Quality Control Check Report. Stage: After Plumbing & Electrical (Apartments)

Flat No.	A-418	Other	-	Sl. No.	41829
Company	MRGV	Project	BRGV	Phase	-
Prepared by	P. Bhaskar	Sign	P.B.	Date	19-05-23
Project Manager	Saxena	Sign	Saxena	Date	19-05-23
Previous stage report no.	41609	Report filed and signed by PM?		☒ Yes ☐ No	
Additions & alterations sheet date	15/04/22	All pages signed by engineer & customer?		☒ Yes ☐ No	
Checked By MD on		MD Sign		For filling	☐ Yes ☐ No

Residency @ Genome Valley

Description		Direction	Owners & Developers :	Date :	23.07.2021	Promoted By
ELECTRICAL PLAN		 N	Modi Realty Genome Valley LLP	Prepared By :		
FLAT NOS. 112, 114, 116, 118, 120 & 122			Project Name & Phase :	Approved By :	Soham Modi	
			BRGV	Scale :	NTS	Phone +91-40-6633333

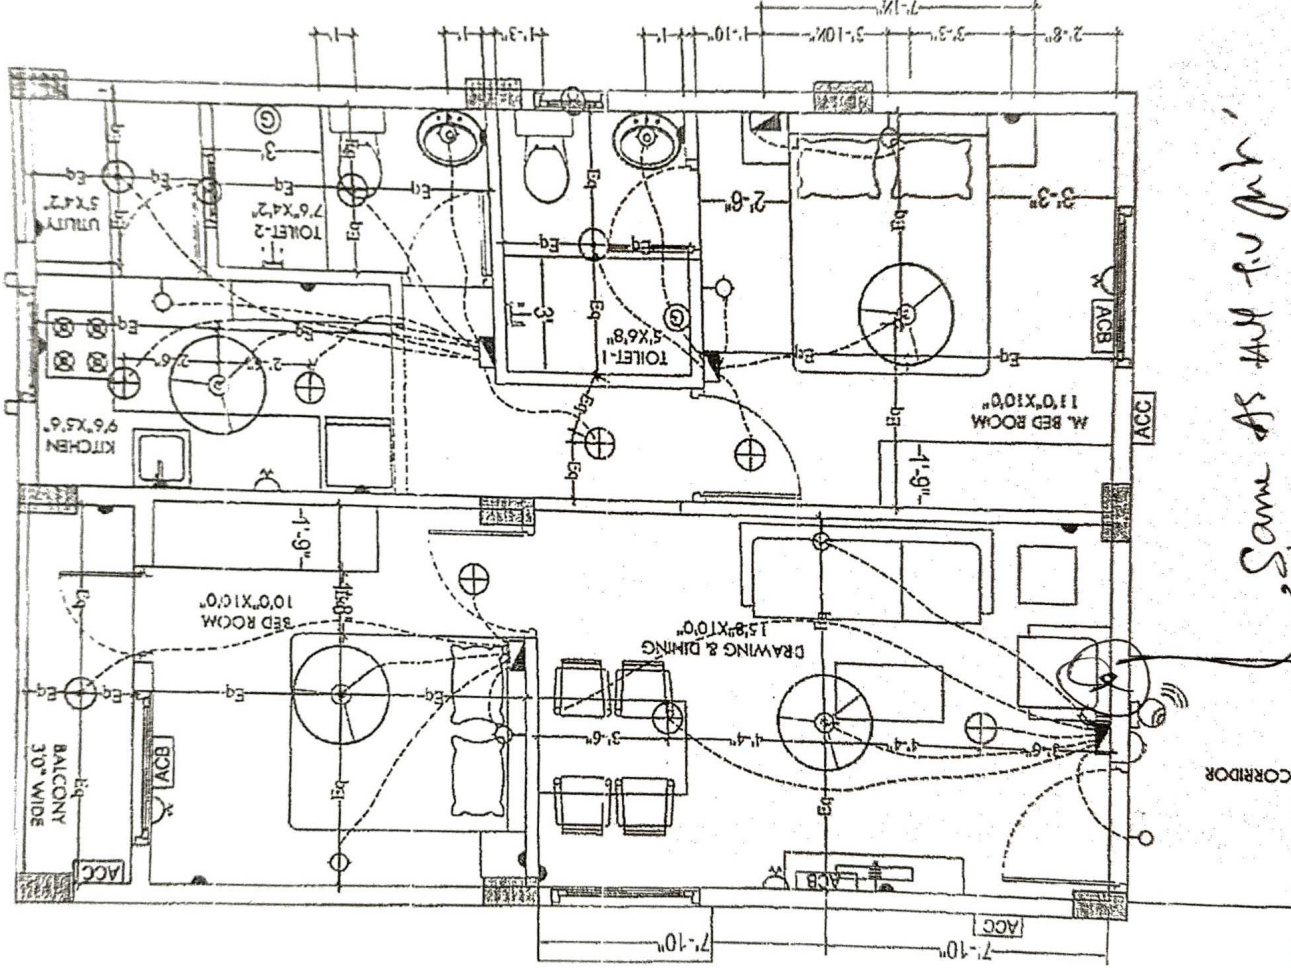
ges in electrical points: (mark on plan)

- ① 16 Amp kitchen.
- ② utility shed.
